FEDERAL COMMUNICATIONS COMMISSION
445 12th Street, S.W.
WASHINGTON DC 20554

In re: W299AU, Zolfo Springs, FL
BPFT-20130520AEY
Facility ID No. 138526

This letter refers to the above-captioned translator application for W299AU, Zolfo Springs, Florida.

THE FOLLOWING IS A LIST OF THE DATA WHICH APPEARS ON THE ABOVE MAP

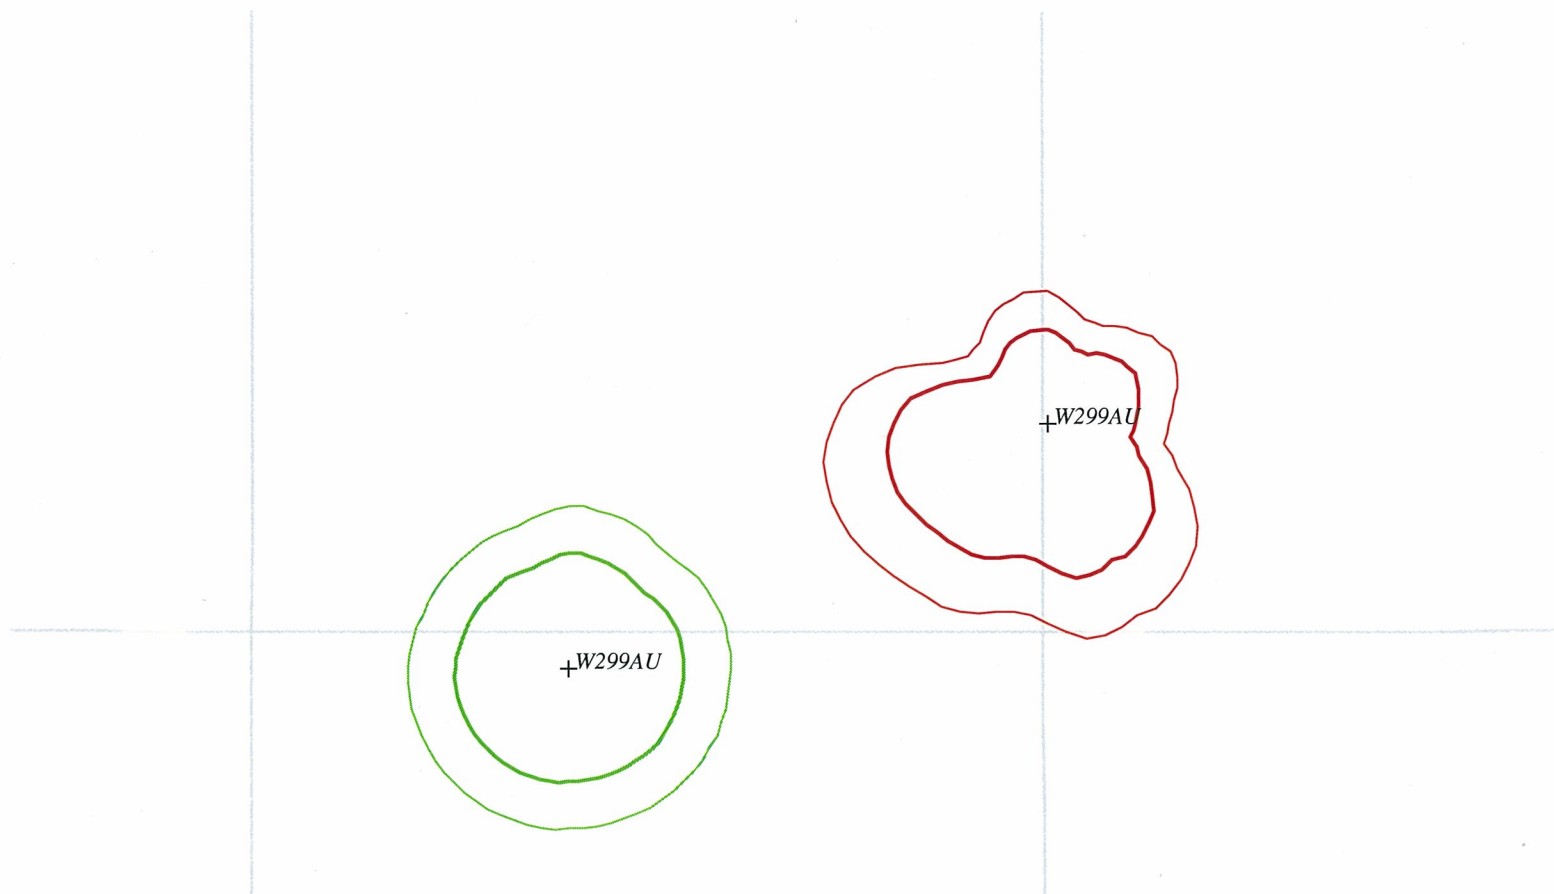
An engineering study reveals that the application is in violation of Section 74.1233(a)(1) of the Commission's Rules. Specifically, the proposed 60 dBu service area fails to provide service to some portion of its 60 dBu licensed service area, (BLFT-20080128ACX). The applicant recognizes this violation and requests waiver of Section 74.1233(a)(1) of the Commission's Rules claiming that the proposal satisfies the standard set forth in the Mattoon letter.¹ However, in order to use the Mattoon waiver standard, the proposed site must be mutually exclusive to its existing licensed facility. Based on the first-adjacent channel relationship between the proposed and licensed facilities, the 60 dBu protected contour and the 54 dBu interfering contour must overlap for the proposal to be considered mutually exclusive with its licensed facility. The application proposes contours that are not mutually exclusive with its licensed facility and therefore the request for waiver of Section 74.1233(a)(1) is denied.

Accordingly, the request for waiver of 74.1233(a)(1), IS HEREBY DENIED, and the Application BPFT-20130520AEY IS HEREBY DISMISSED. This action is taken pursuant to 47 C.F.R. § 0.283.
